WATERVUE

643-651 HUNTER STREET NEWCASTLE NSW 2300

DEVELOPMENT APPLICATION SHEET LIST		
DRAWING NO.	TITLE	REVISION
DA000	PLAN - LOCATION & DRAWING SCHEDULE	F
DA002	SITE ANALYSIS	B
DA003	PREDICT LOCATION PLAN	C
DA005	SITE PLAN	B
DA006	SHADOW DIAGRAMS	B
DA007	SHADOW DIAGRAMS	B
DA008	SHADOW DIAGRAMS	A
DA009	SOLAR ACCESS DIAGRAM	B
DA010	VENTILATION DIAGRAMS	B
DA011	PLANNING - GFA	C
DA012	UNIT AREA FOR CARPARKING GEN.	B
DA101	GROUND FLOOR	E
DA102	PARKING LEVEL 1	D
DA103	PARKING LEVEL 2	C
DA104	PARKING LEVEL 3	C
DA105	PLAN - PODIUM	E
DA106	PLAN - TYPICAL LOWER	D
DA107	PLAN - TYPICAL UPPER	C
DA111	PLAN - PENTHOUSES	B
DA112	ROOF	B
DA200	STREETSCAPE ELEVATIONS	B
DA201	ELEVATIONS - NORTH AND EAST	F
DA202	ELEVATIONS - SOUTH AND WEST	C
DA301	SECTIONS	C
DA321	RAMP SECTION CARPARK	C
DA401	PERSPECTIVE	B
DA402	PERSPECTIVE	B
DA403	PERSPECTIVE	B
DA409	MATERIALS + FINISHES	B
DA801	PODIUM LEVEL PRIVACY SCREENS	A
DA802	SIGNAGE DESIGN INTENT	A

DRAWING No. **DA002**
DRAWING TITLE **SITE ANALYSIS**
SCALE
DATE **2022**

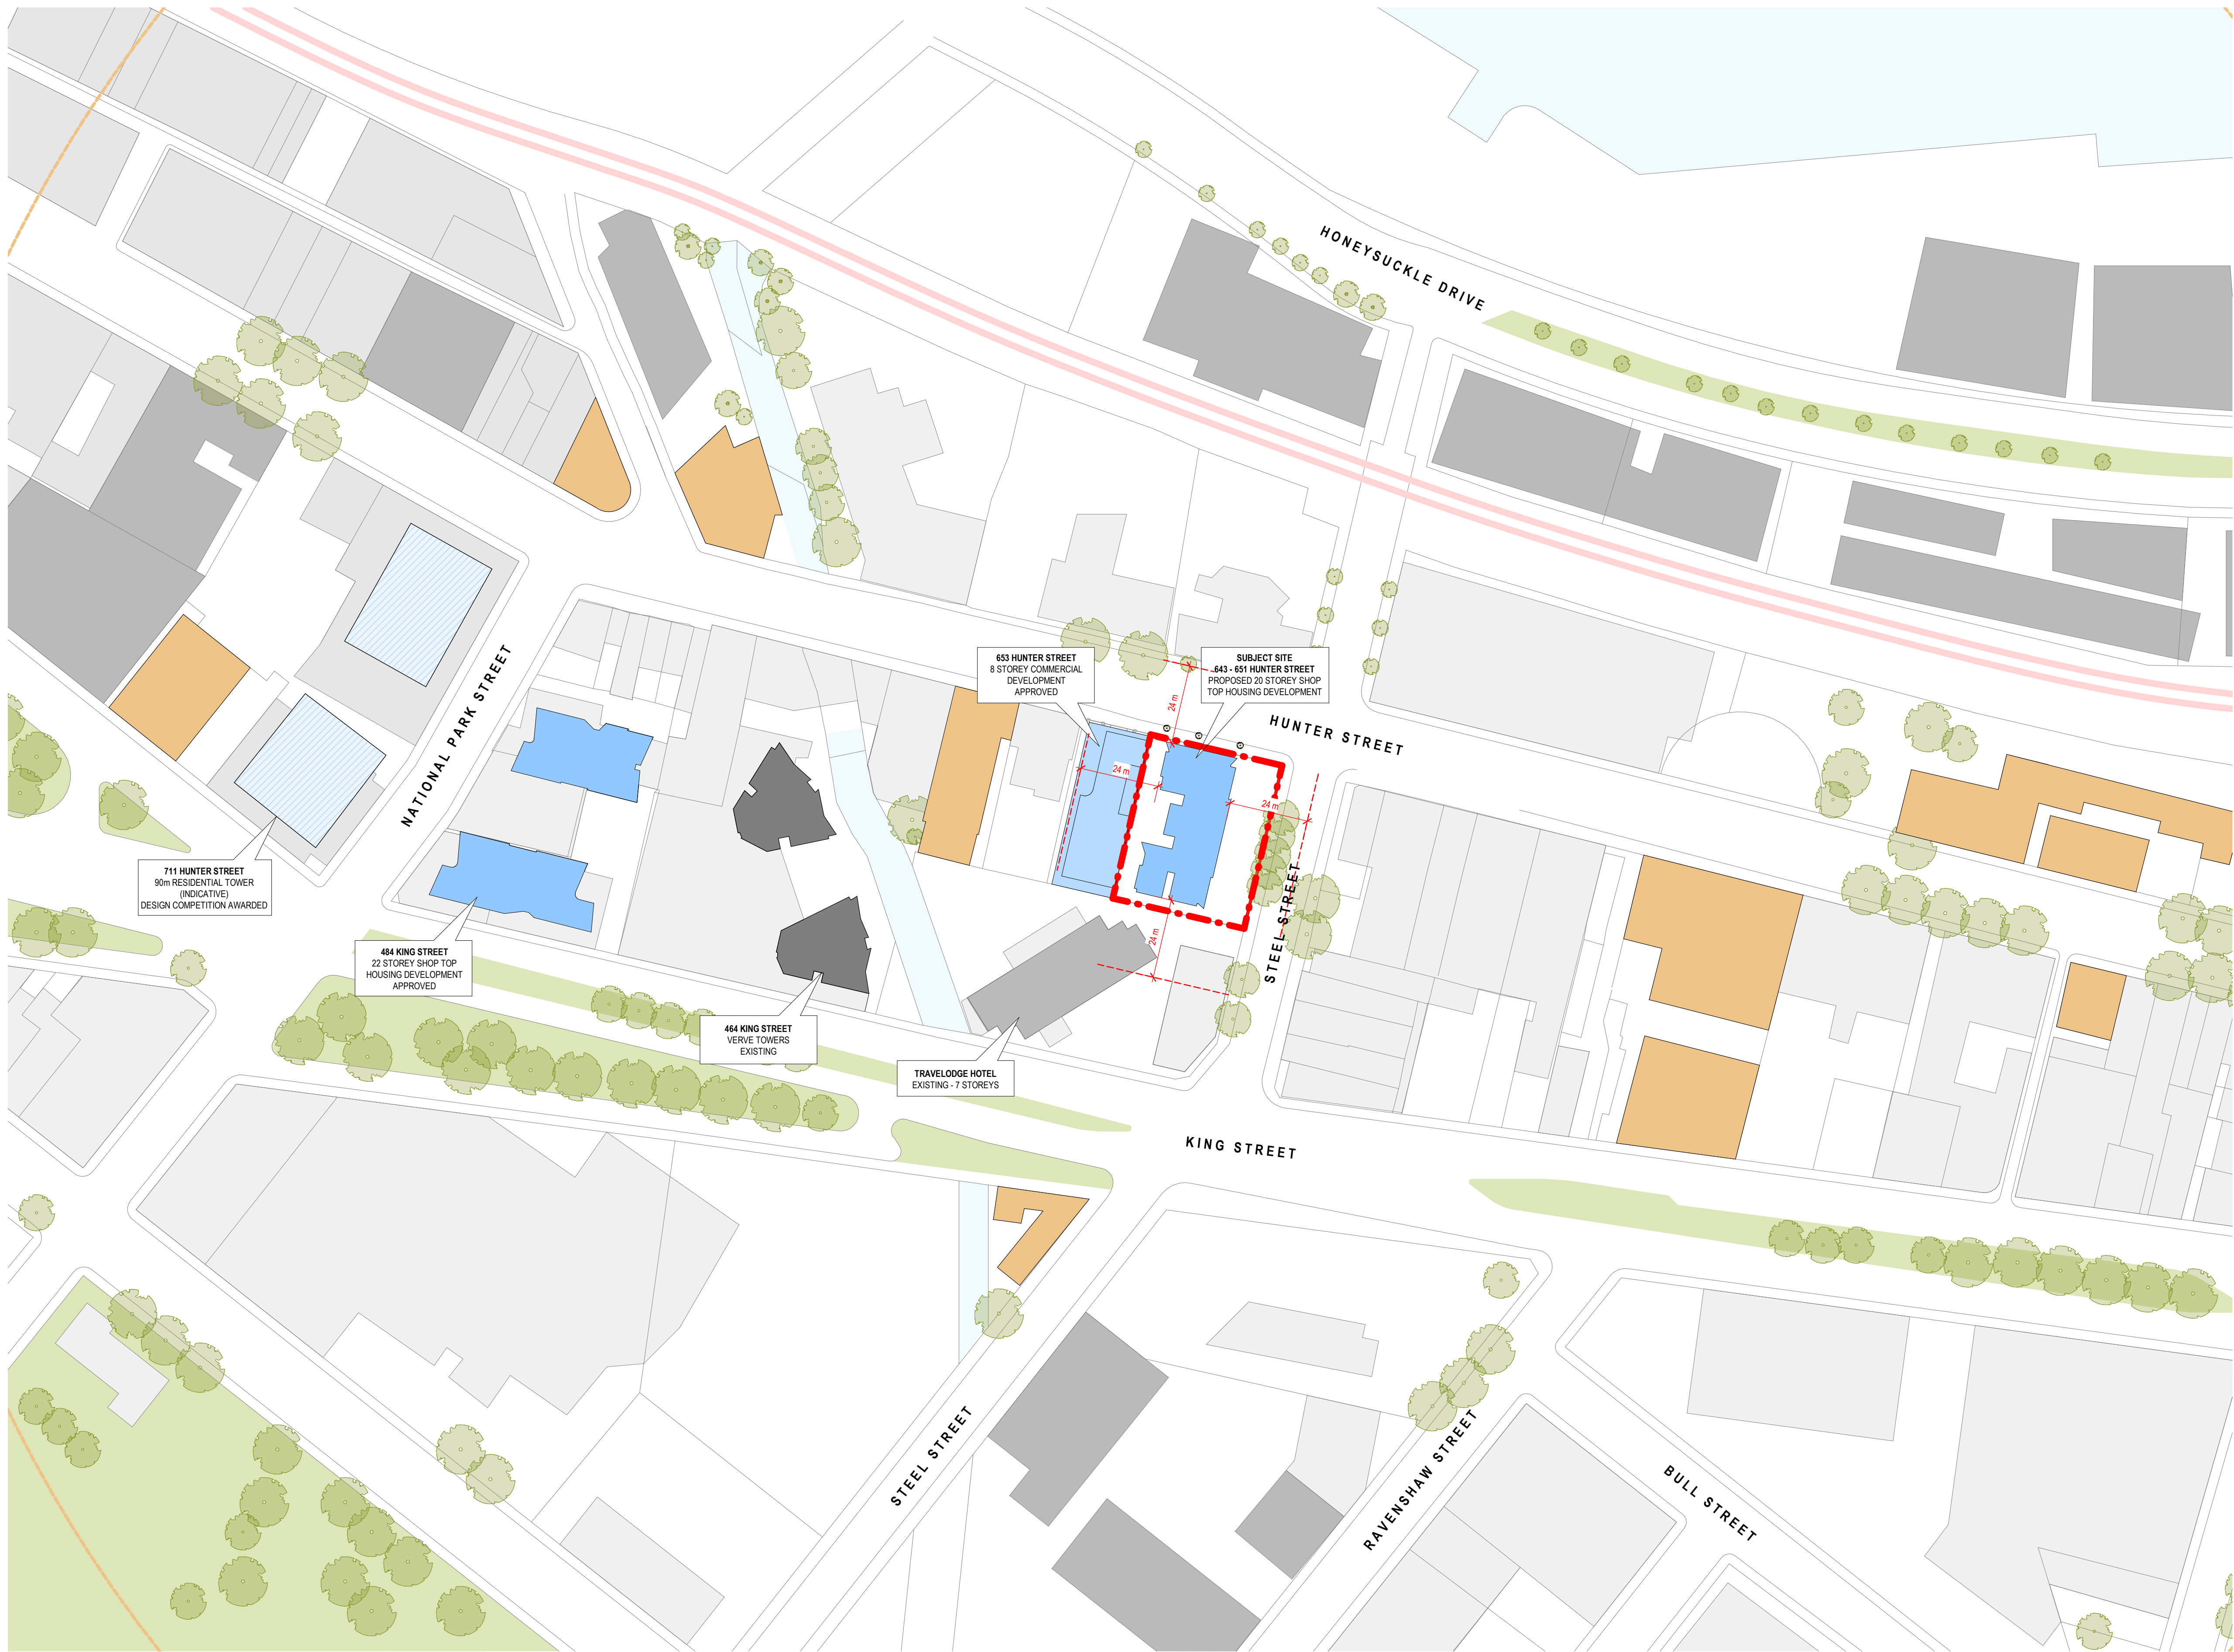
DA RfIs - 27.03.2023
24m BUILDING SEPARATION LINE ABOVE 45m INDICATED
PRIVACY SCREEN LOCATION CLARIFIED

DRAWING No. **DA011**
DRAWING TITLE **PLANNING - GFA**
SCALE **1 : 250 @ A1**
DATE **2022**

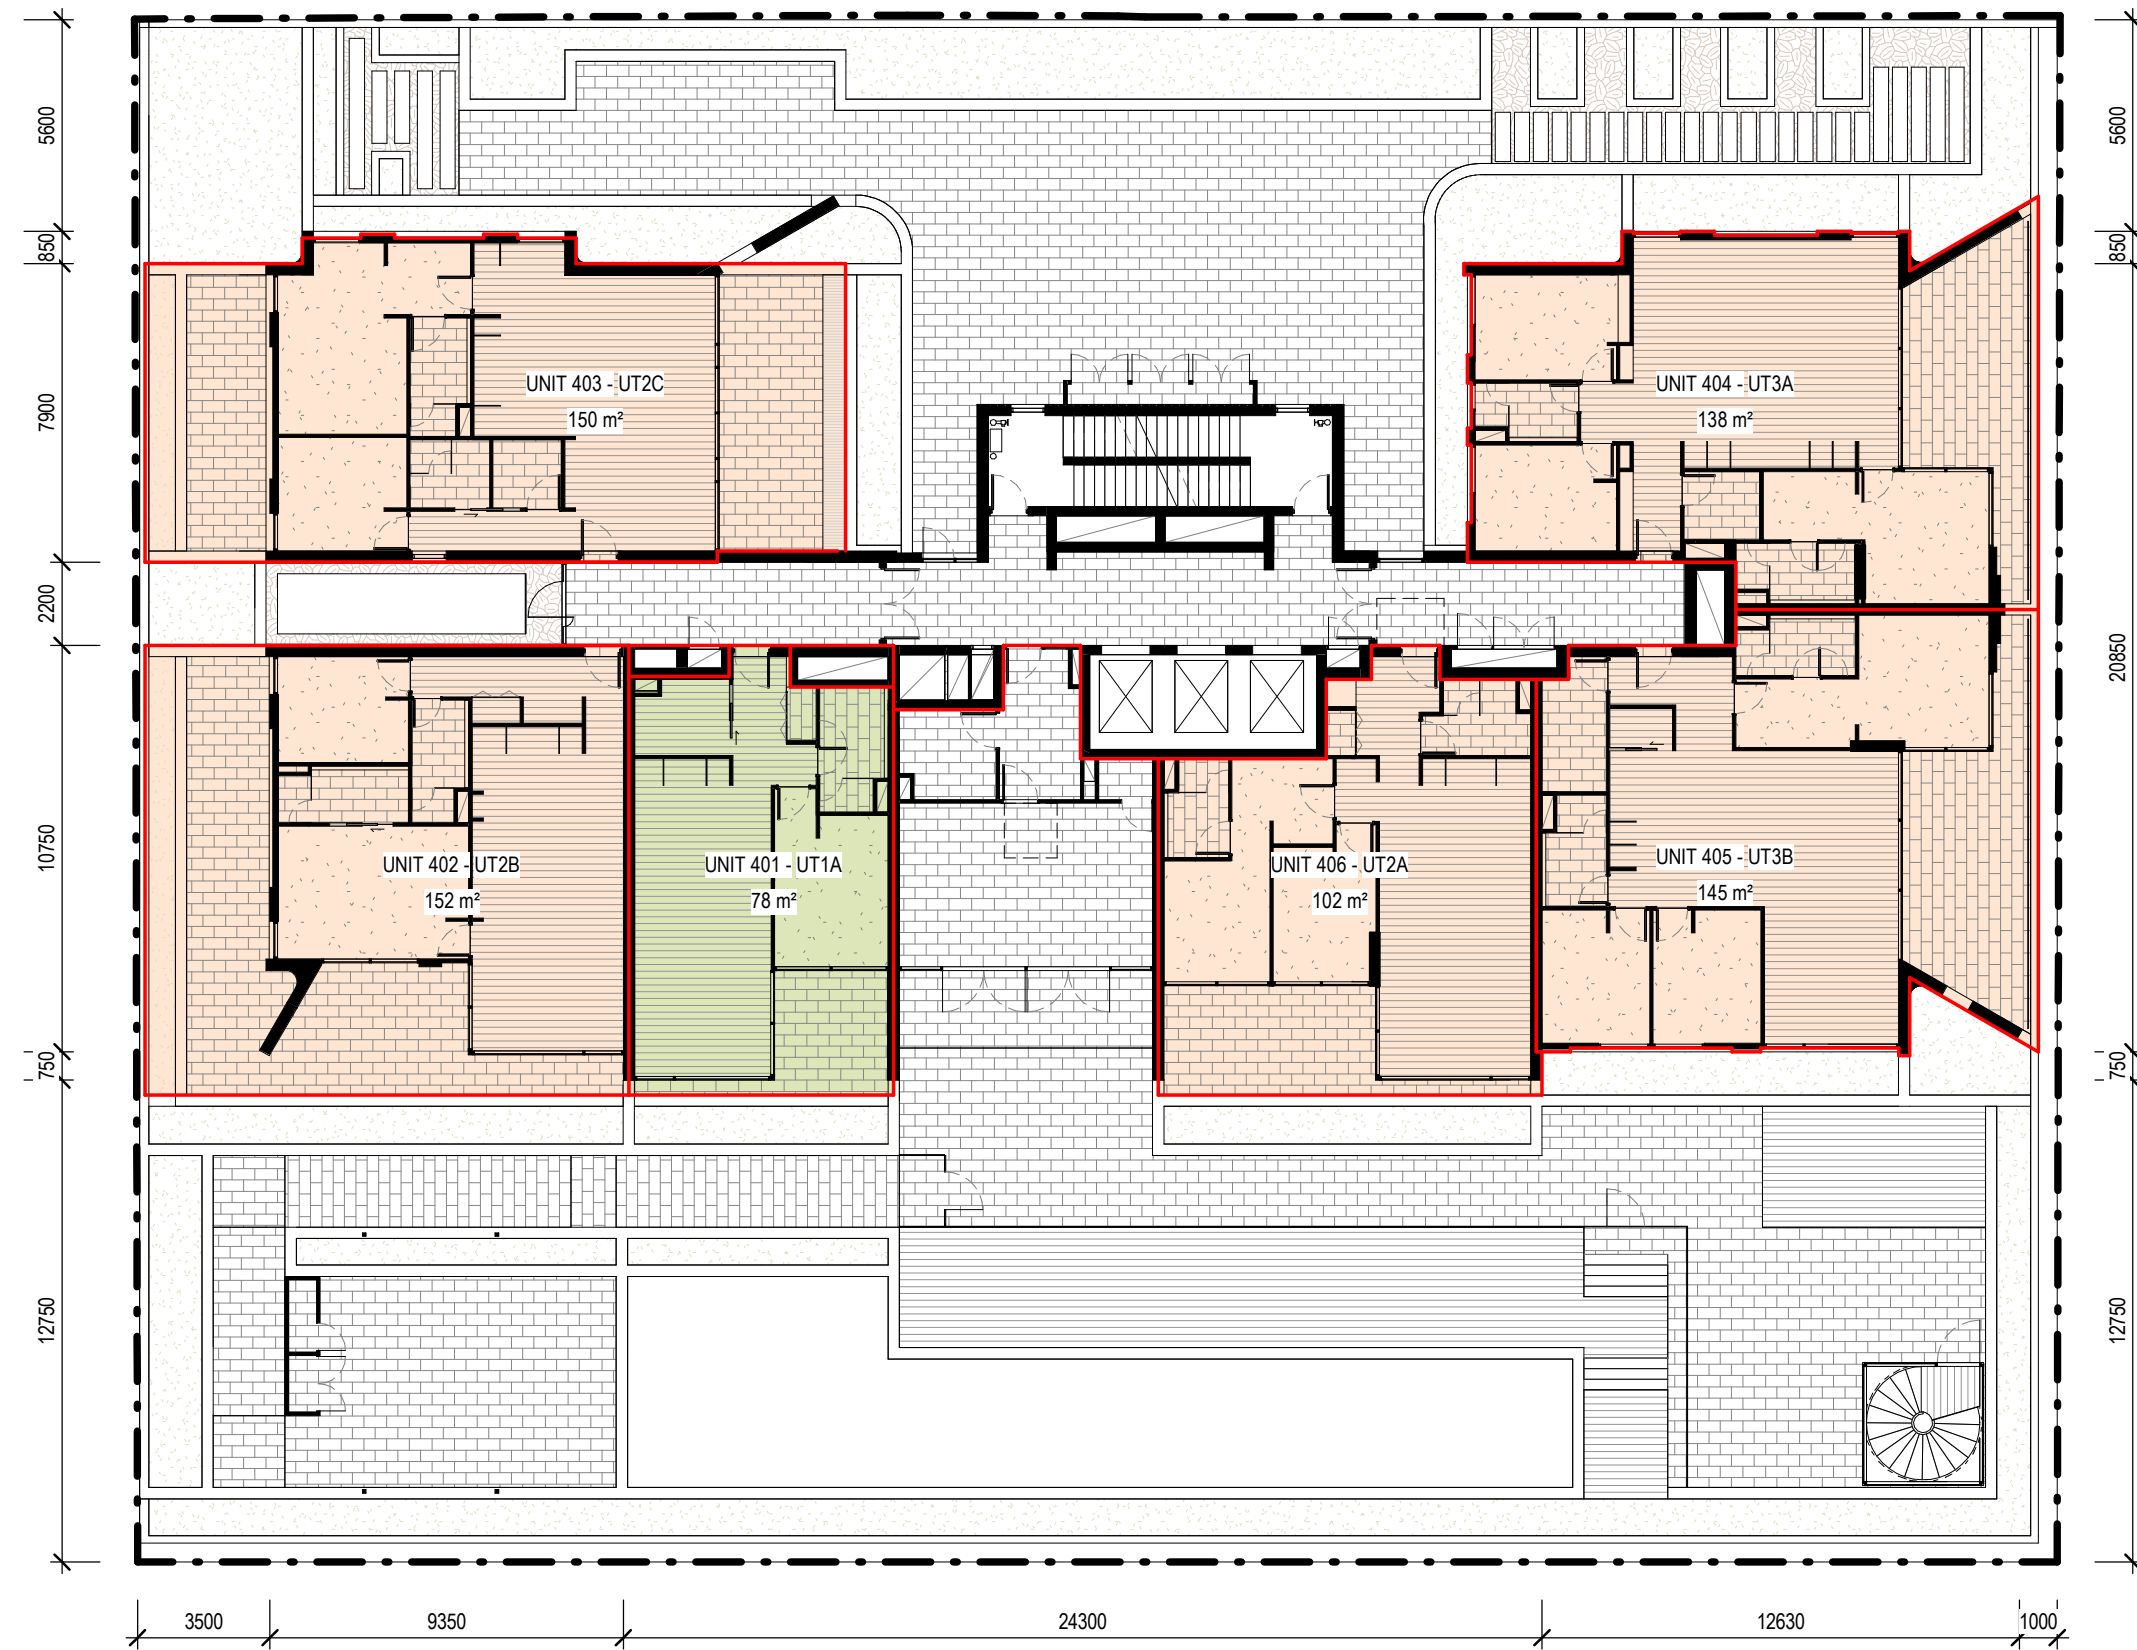
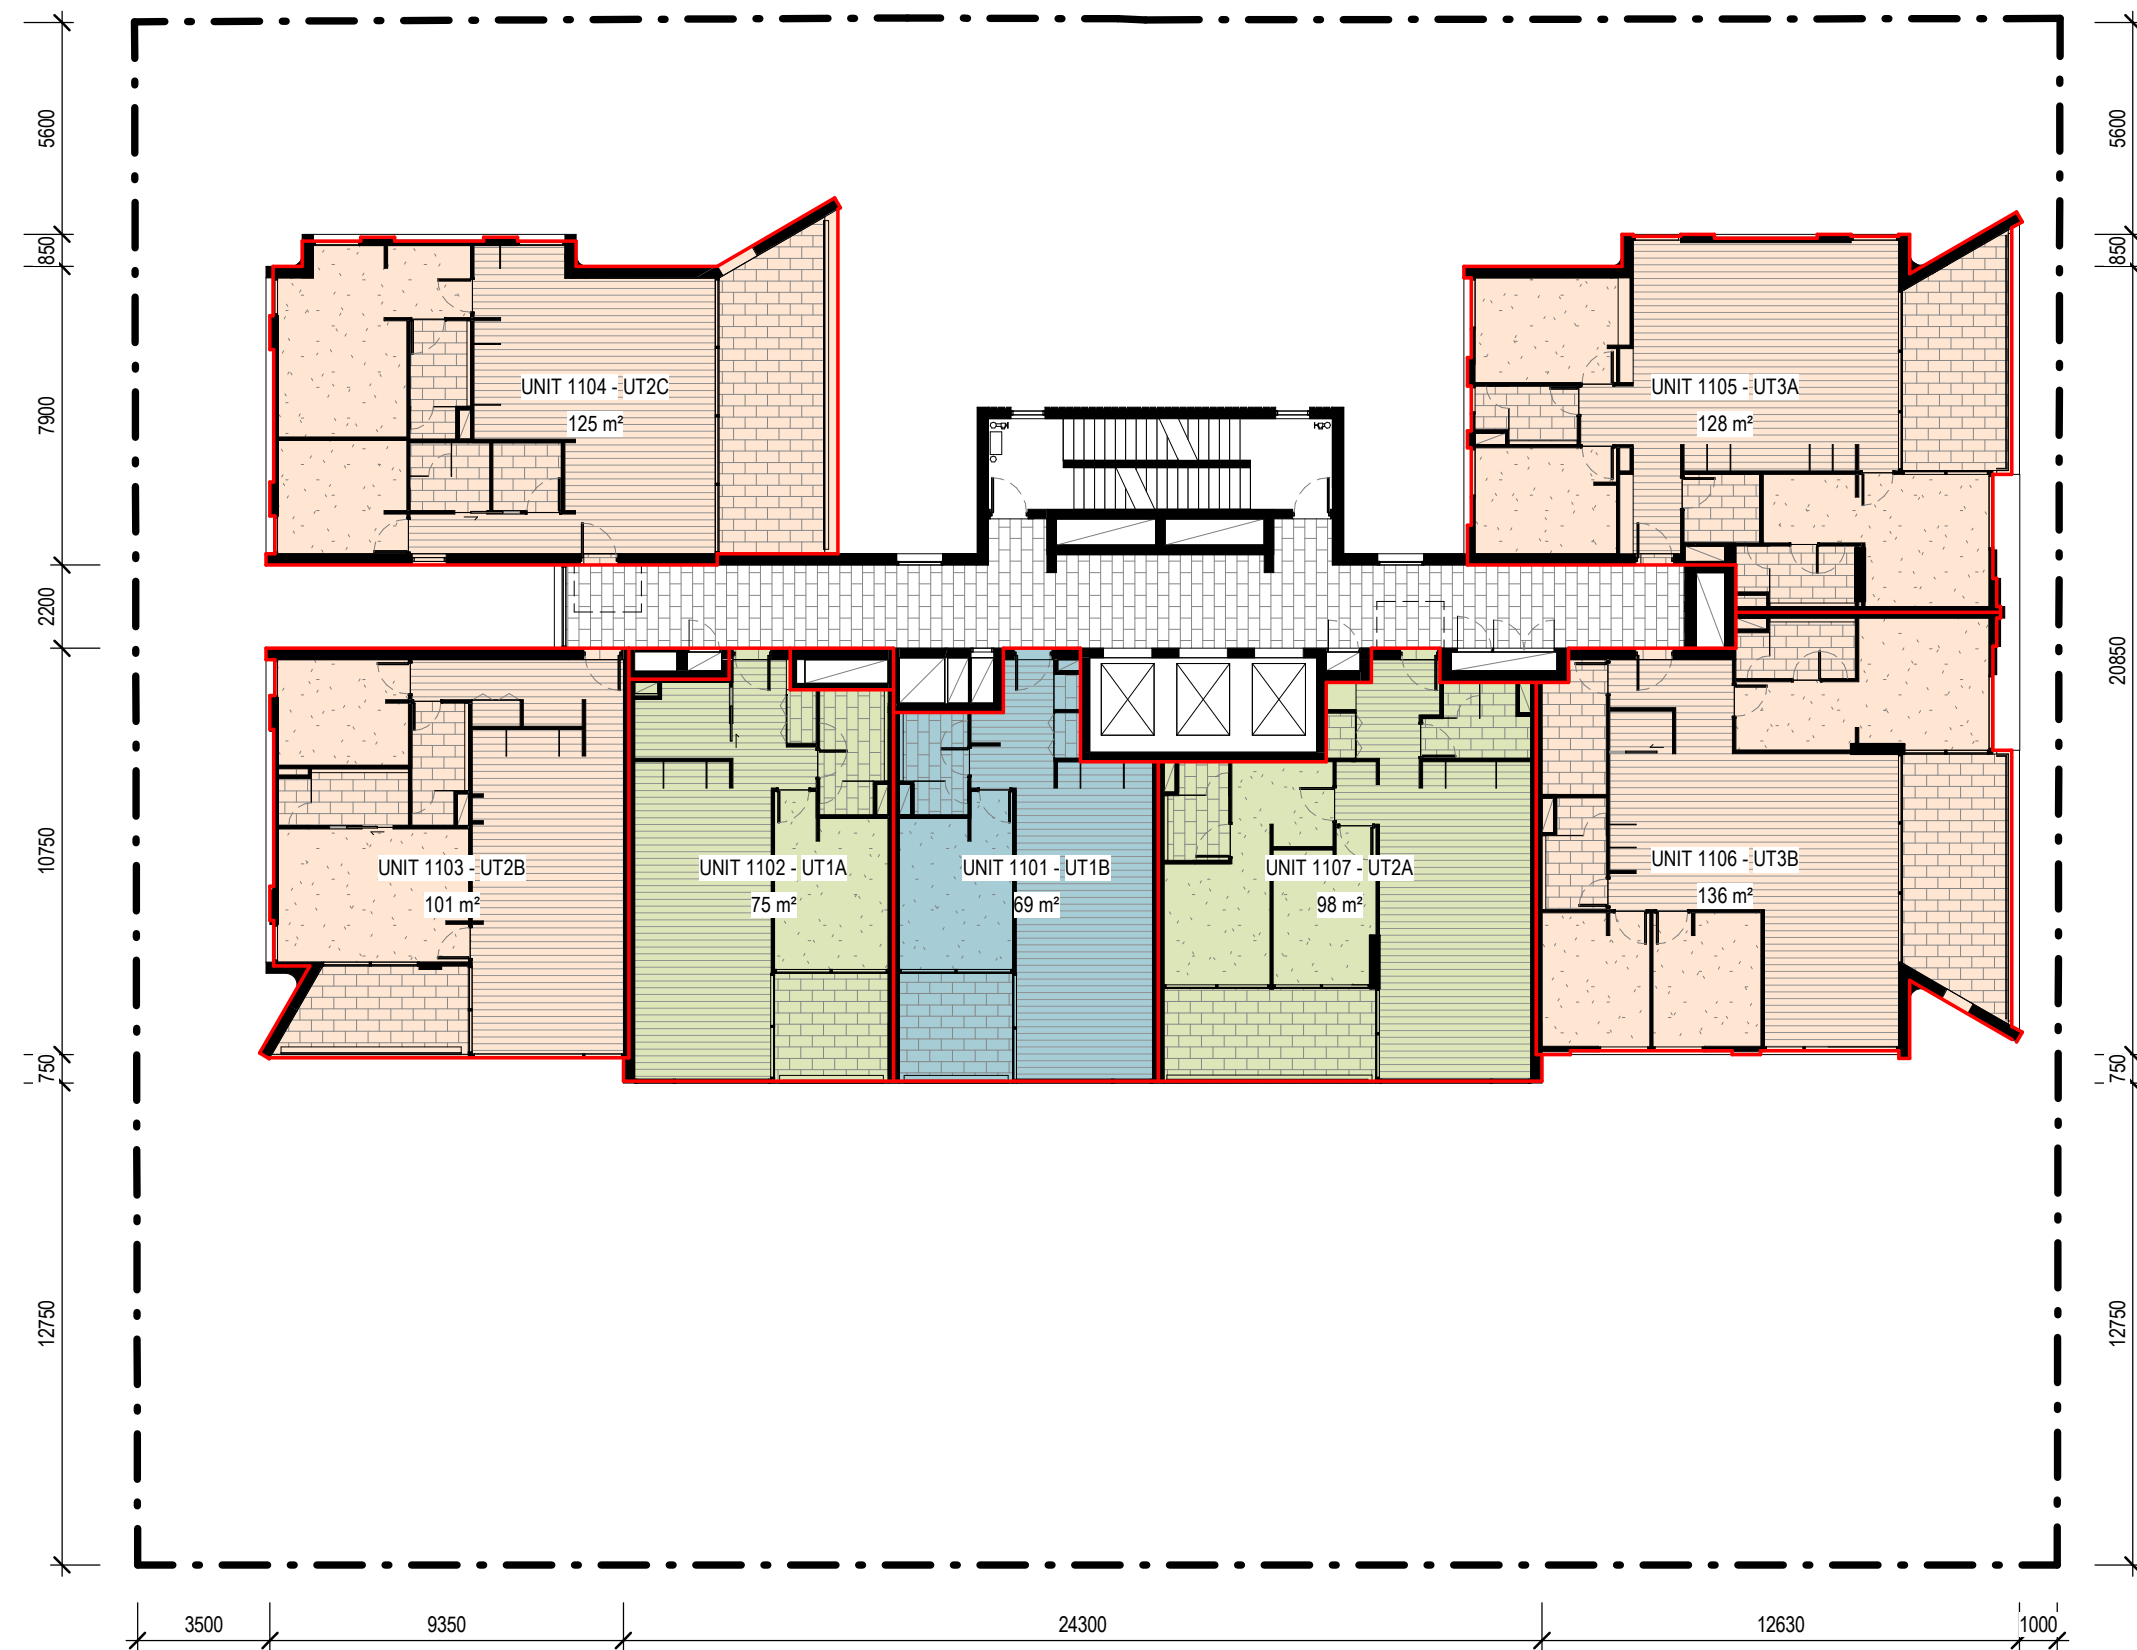
- NOTCHES IN AWNING ADDED
- FUTURE STREET TREE CLEARANCE INDICATED
- ADDITIONAL RAMP SECTION PROVIDED
- RAMP EDGE CONDITION CLARIFIED
- COMMERCIAL TENANCY STORAGE, WICS, COMMS ROOM, MAIL ROOM RECONFIGURED TO CREATE FLOOD EVACUATION PATH
- STAIRS REMOVED
- STAIRS REMOVED RAMP ADDED
- GFA REVISED AS PER CHANGES ABOVE
